REMARKS/ARGUMENT

AMENDMENT TO THE DRAWING(S)

FIG. 1 PRIOR ART

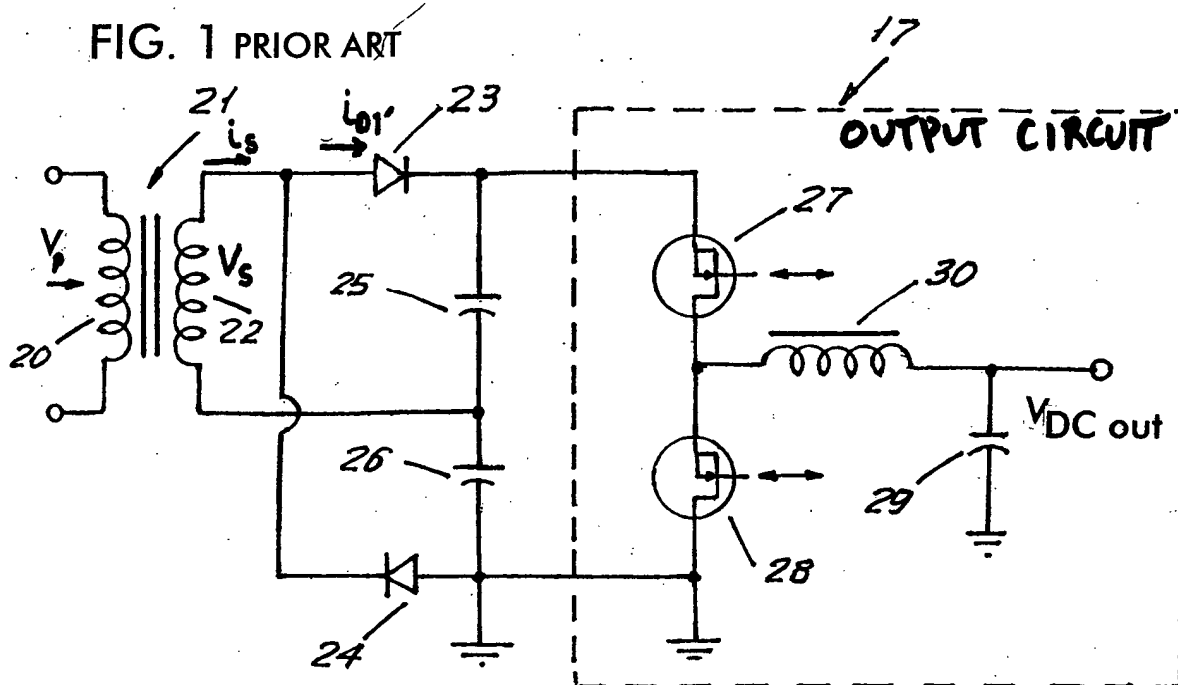
The Examiner also suggests labeling boxes 7 and 17 in Figures 2A and 1, respectively. Applicants have amended the Figures herein to make clear that reference numerals "7" and "17" both refer to respective output circuits.

FIG. 2A

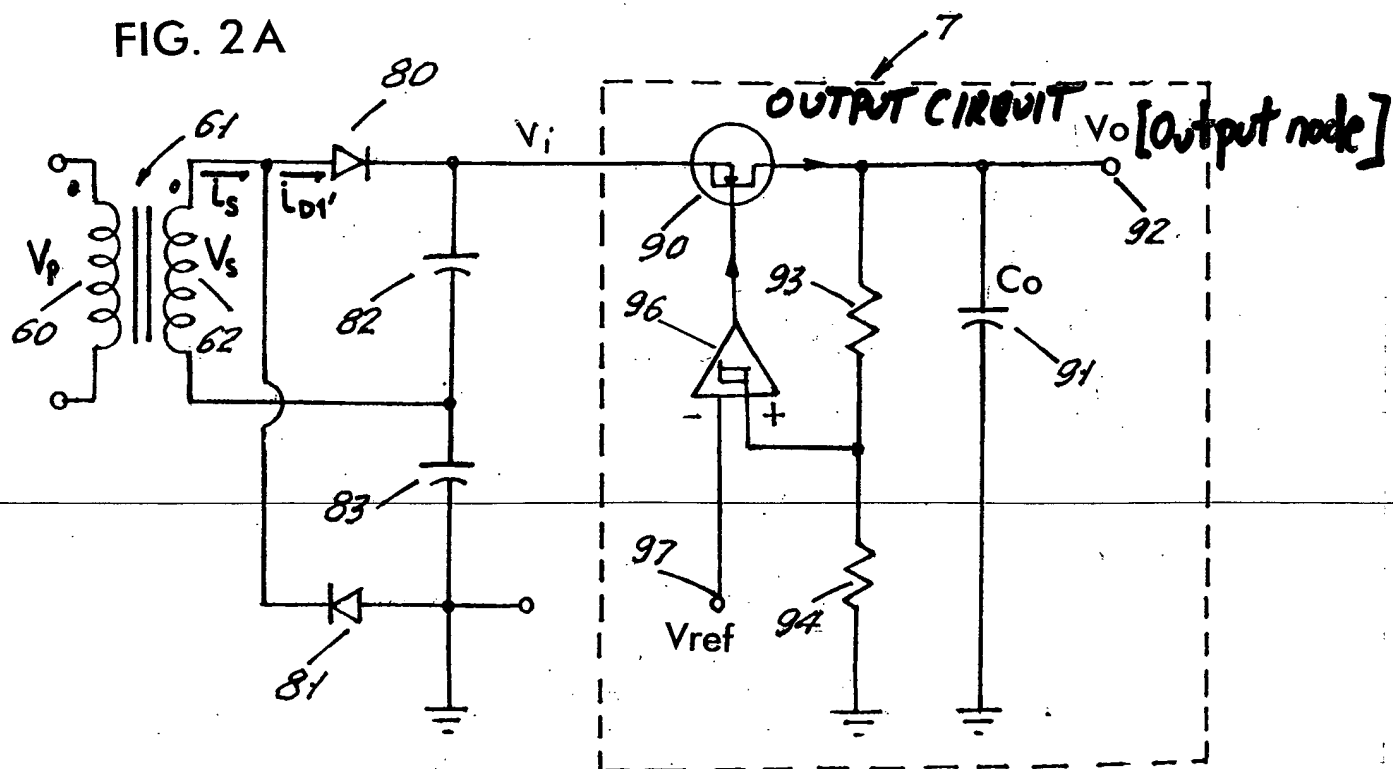
The Examiner also contends that it is unclear what V_i is in Figure 2A. V_i is the input to the output circuit 7.

The Examiner also contends that it is unclear which node is the "output node" in Figure 2A. Figure 2A has been amended herein to make clear that V_o is the output node.

FIG. 2B

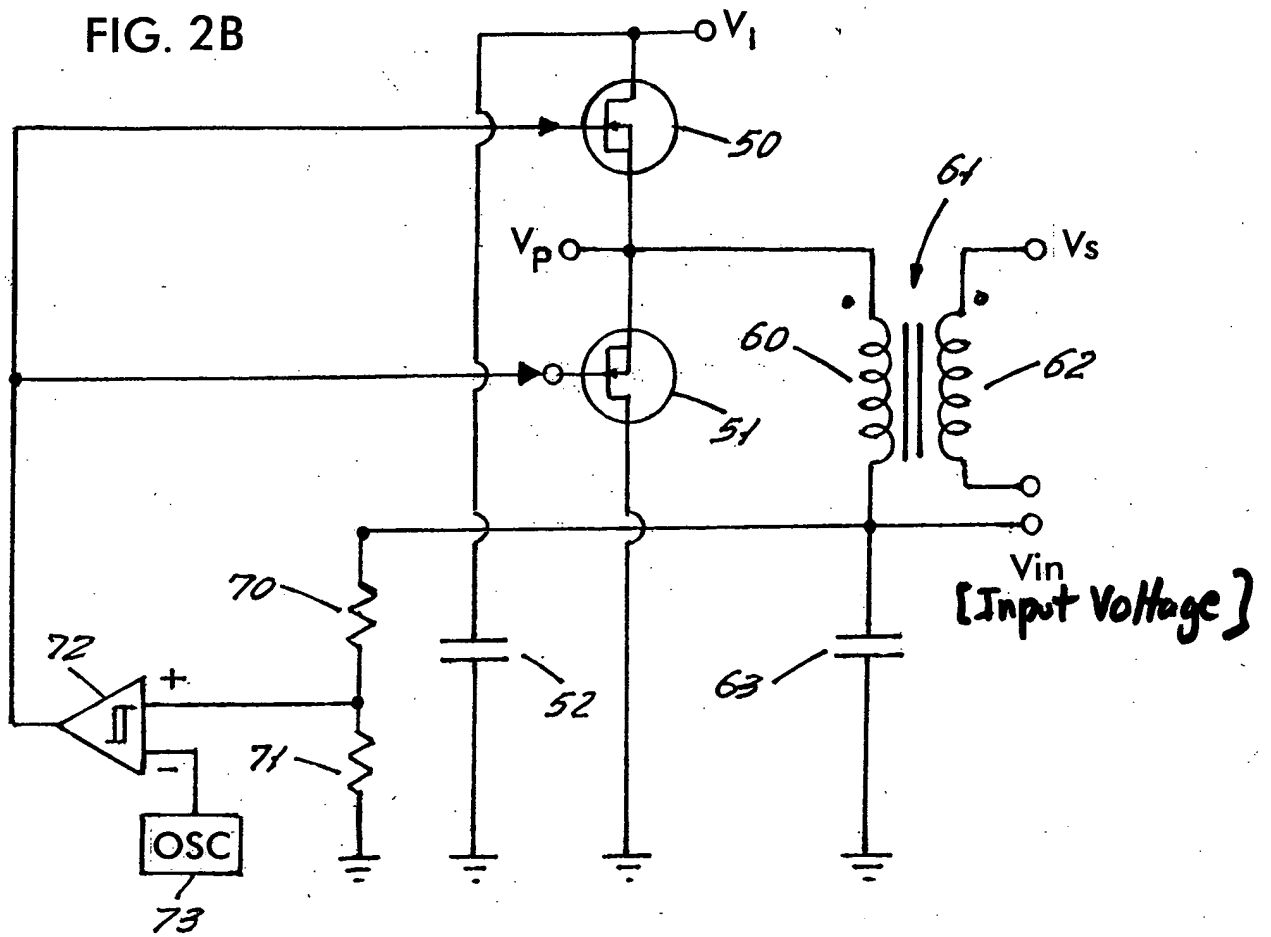
First, the Examiner contends that it is not clear where V_{IN} of Figures 2A and 2B is from. Applicants direct the Examiner to Figure 2B, which illustrates V_{IN} as an input voltage to the primary winding circuit. V_{IN} is neither an input nor an output to the circuit illustrated in Figure 2A. As described in paragraph [0023] of the Specification, V_{IN} is, in the illustrated embodiment, an input voltage connected to the opposite end of the primary winding 60 across capacitor 63 having a capacitance C2 and a resistor divider 70, 71. It is further described in paragraph 40. The duty cycle of the PWM modulator is proportional to V_{IN} . To eliminate any ambiguity, Figure 2B has been amended herein to make clear that V_{IN} is an input voltage.
